**2019-008 ZBA – Community Housing Resource, Inc.** seeks approval for a Comprehensive Permit pursuant to G.L. c. 40B, §§20-23 to create 40 residential rental units, of which not less than 25% or 10 units shall be restricted as affordable for low or moderate income persons or families, to be constructed on property located at 22 Highland Road, as shown on Assessor's Map 36 and Parcel 238-0 containing 3.91 acres of land area.

Re: Erosion Control Report Peer Review, Cloverleaf Parcel  
Highland Road  
Truro, Massachusetts

The Horsley Witten Group, Inc. (HW) has reviewed the “Environmental Management Plan prepared by Safe Harbor Environmental Services provided to us on July 2, 2020 by J.M. O’Reilly & Associates (Applicant’s Engineer) regarding the Comprehensive Permit submitted by Community Housing Resource, Incorporated (Applicant) for the residential redevelopment of the Cloverleaf Parcel located on Highland Road in Truro, Massachusetts.

SKETCH PLAN SHOWING  
 EROSION CONTROL FOR STEEP SLOPES  
 AT  
**CLOVERLEAF TRURO RENTAL HOUSING**  
 PREPARED FOR  
**COMMUNITY HOUSING RESOURCE**

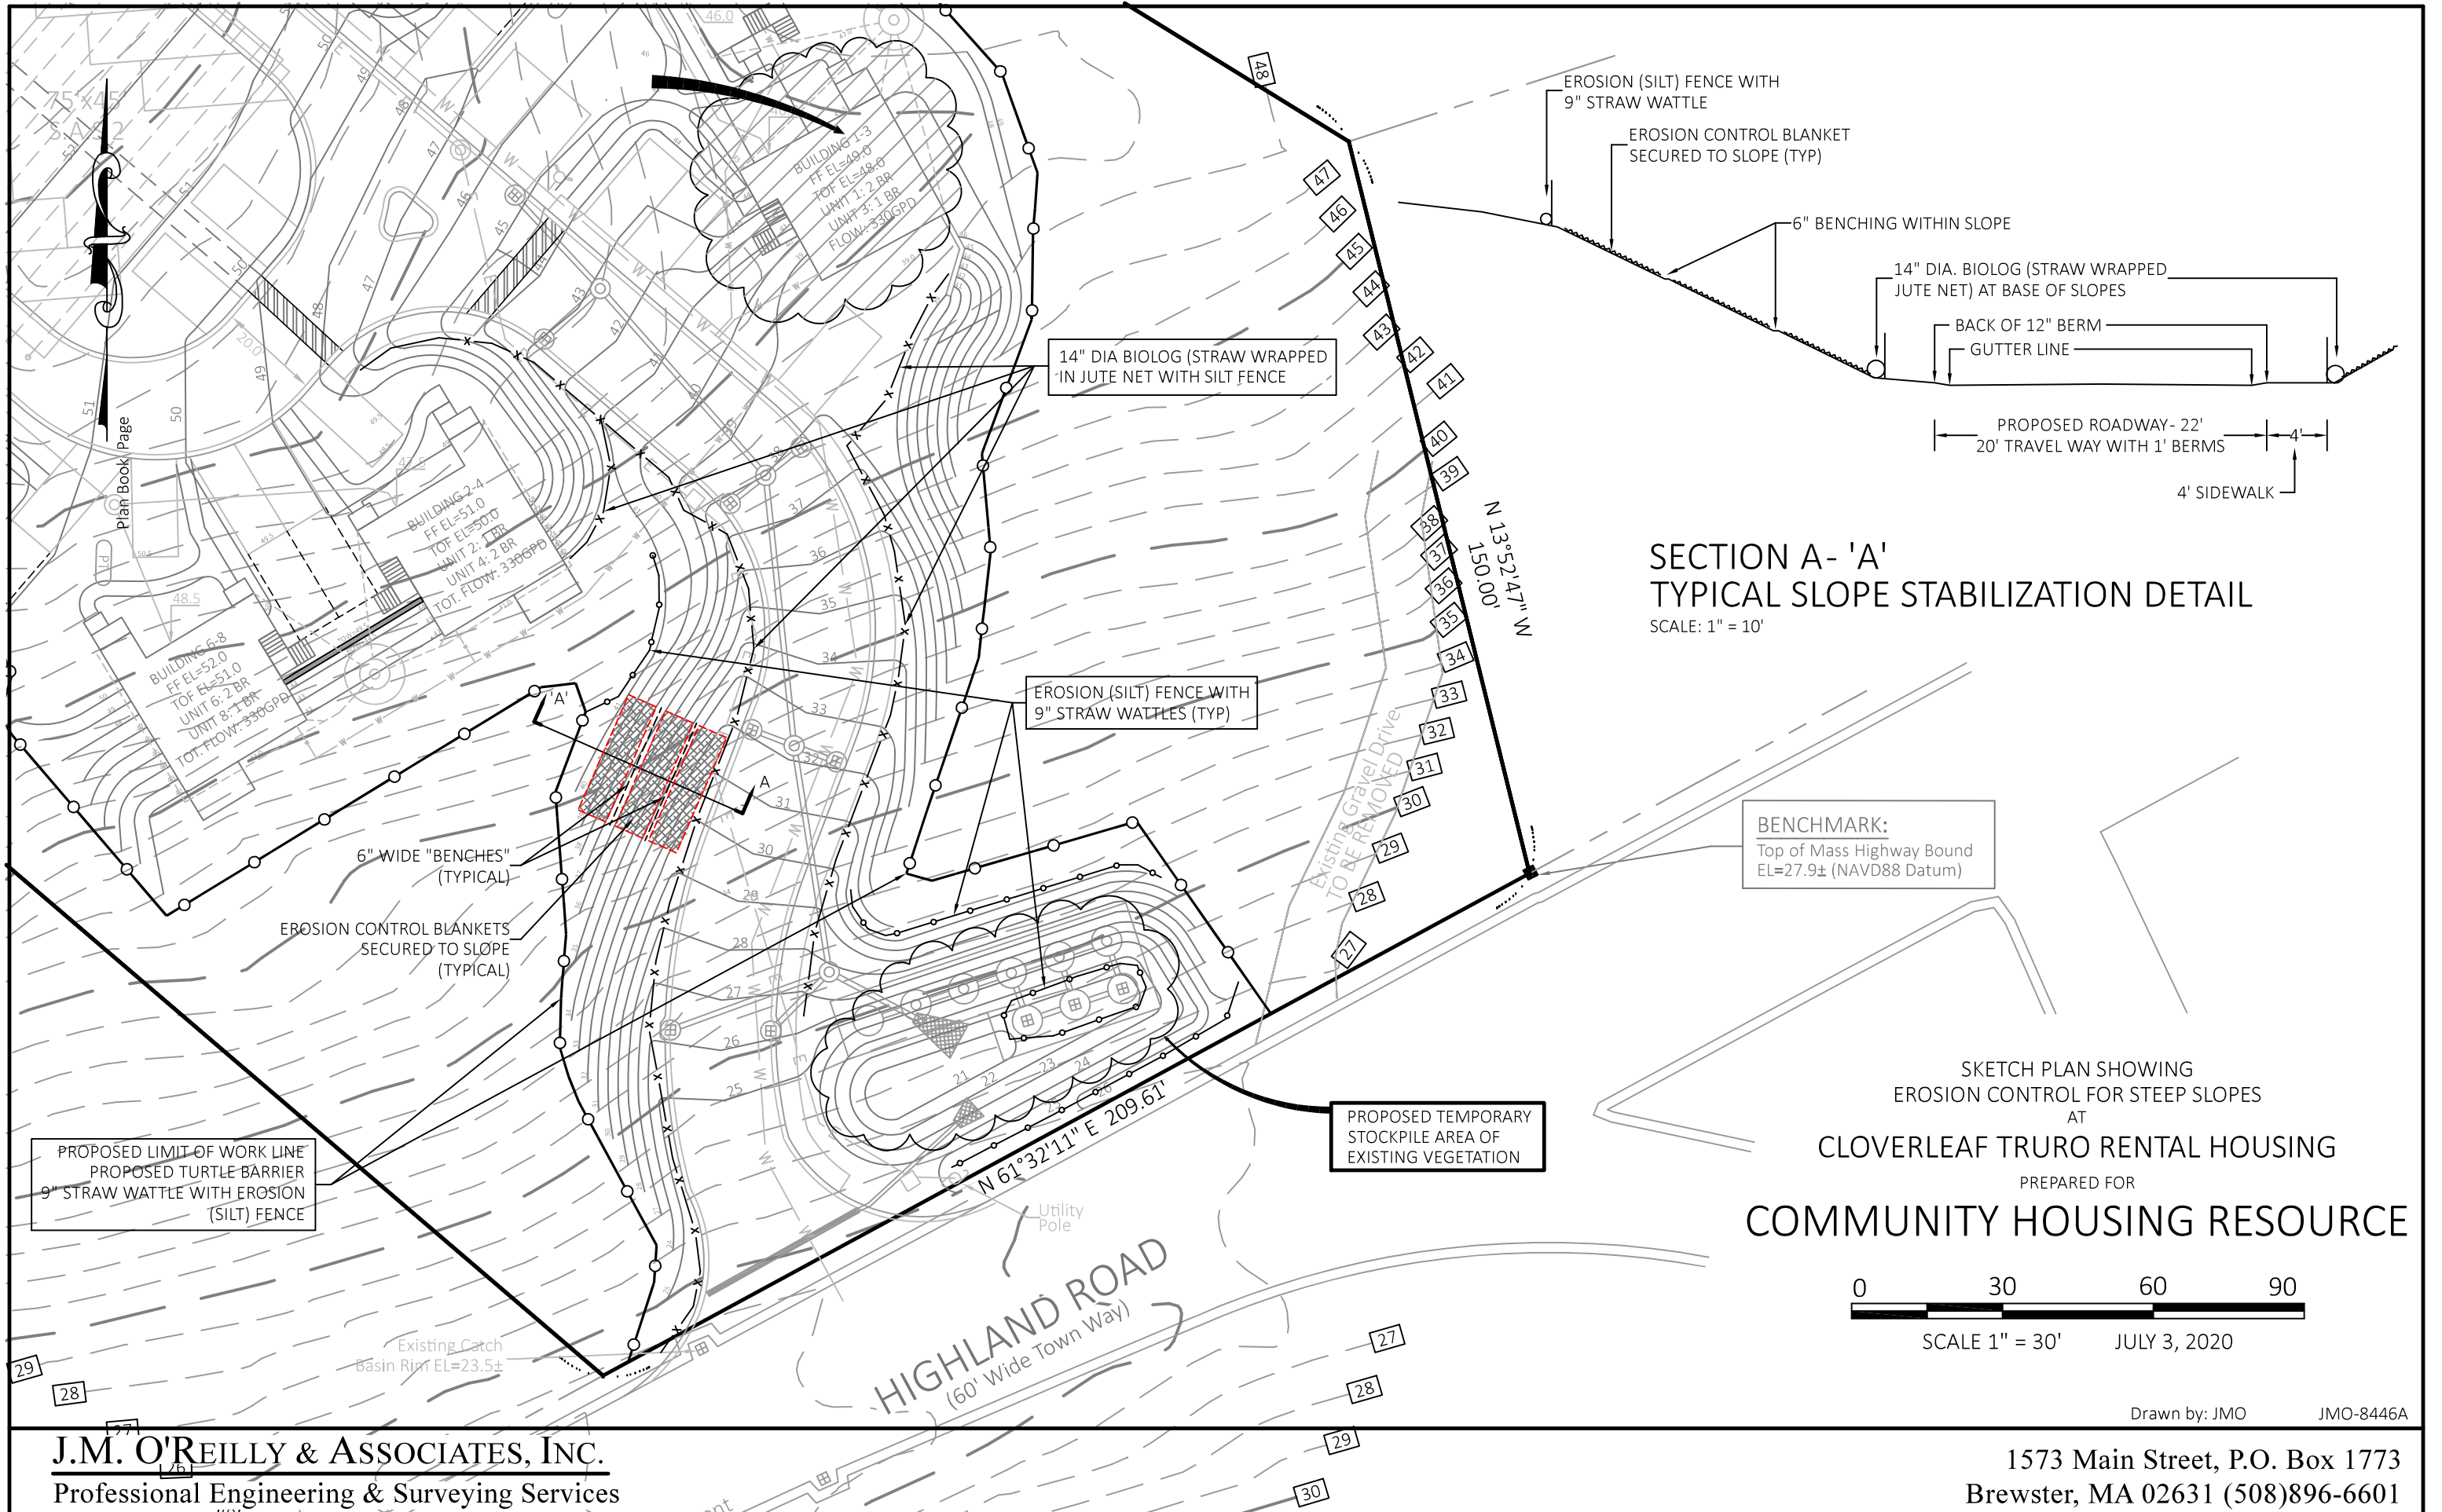
The information provided is general in nature, and the only detail relating to ESC is a silt fence/erosion control detail. The proposed locations for silt fence and biologs are only shown near the community entrance. These details should be provided for the entire site.

The information provided is general in nature, and the only detail relating to ESC is a silt fence/erosion control detail. The proposed locations for silt fence and biologs are only shown near the community entrance. These details should be provided for the entire site.

***The referenced EC Detail, clearly and specifically identifies related components of the system and how they can be integrated; Site Plan # 1 specifically shows EC system in place around the entire site; The EMP clearly states that silt fencing or silt fencing biolog EC systems shall be used as necessary, to maintain performance standards; That these systems be monitored and maintained by trained Safe Harbor workers to maintain zero discharge performance standards. (EMP, July 6, 2020, pgs2-3).***
